Consolidated text of amendments and amendment proposals to CEVNI 5

The present document contains the consolidated text of:

- TRANS/SC.3/115/Rev.3/Amend.1 and TRANS/SC.3/115/Rev.3/Amend.2
- The amendments preliminarily approved by SC.3/WP.3 at its fifty-fourth and fifty-fifth sessions (ECE/TRANS/SC.3/2019/8, annex I)
- Decisions of the thirtieth meeting of the CEVNI Expert Group (CEVNI EG/2019/12) (in square brackets and highlighted blue).

C.5

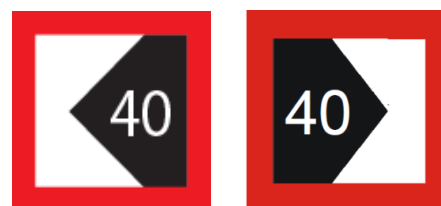
50. *Modify*

The channel lies at a distance from the bank where the sign is installed; the figure shown on the sign indicates the distance in metres, measured from the sign, to which vessels should keep

(fig. 23 bis)

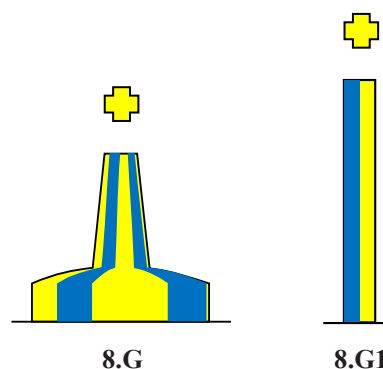
51. In the end of section A, *add* a new paragraph

3. Marking of new dangers

The term “New Danger” is used to describe newly discovered hazards not yet shown in nautical documents. New Dangers include naturally occurring obstructions such as sand banks or rocks or man-made dangers such as wrecks.

Colour: Blue and yellow vertical stripes in equal number dimensions (minimum 4 stripes and maximum 8)

Form: pillar or spar

Topmark (if any): vertical or perpendicular yellow cross

Light (when fitted):

Colour: yellow/blue alternating

Rhythm: one second of blue light and one second of yellow light with 0.5 seconds of darkness between.

(fig.24 bis)

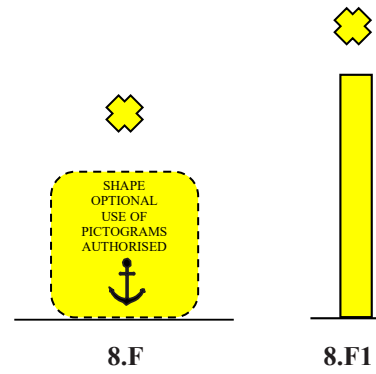
52. *After* section B, *add* a new section

B BIS. SPECIAL MARKS

Marks not primarily intended to assist navigation but which indicate a special area or feature referred to in appropriate documents, such as military exercise zone marks, recreation zone marks.

Colour: yellow
Shape: optional, but not conflicting with navigational marks
Topmark, if any: single yellow, "X" shape Light:
Colour: yellow
Rhythm: any, other than those described in A.2, A.3 and B.
